Date: October 11, 2006

**GTHB & GTHC Return Air Dimension Error
 IOM Literature**

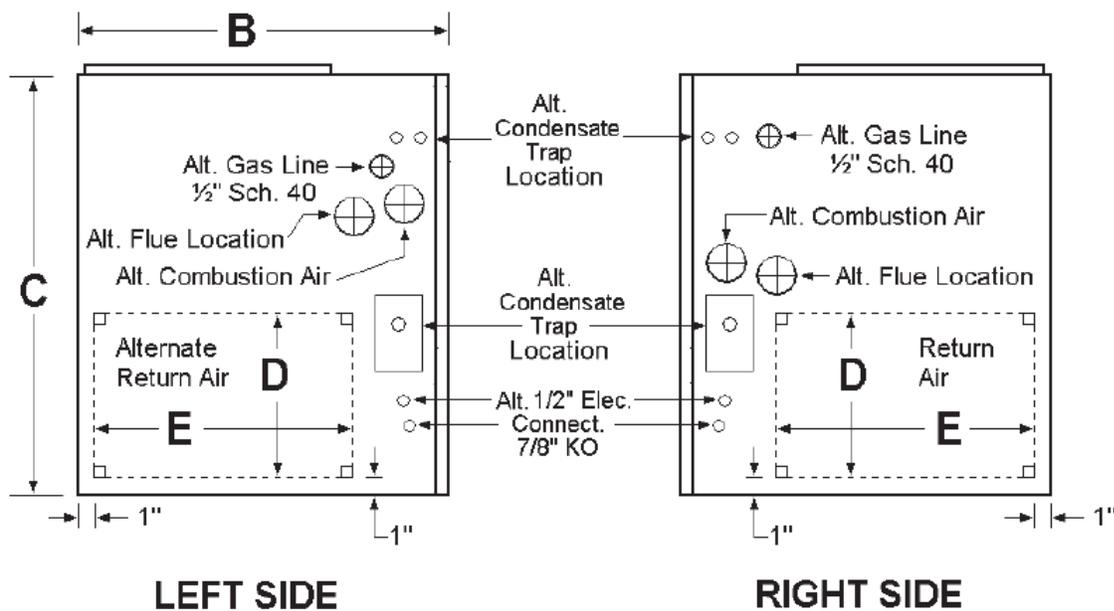
An error in the Installation Manual and Operating Instructions for the GTHB and GTHC - Natural Gas and Propane Gas High Efficiency (Condensing) Warm Air Furnaces has been identified for the return air opening. The literature incorrectly indicates the Return Air dimensions. The correct Return Air dimensions (D x E) are 14" x 22".
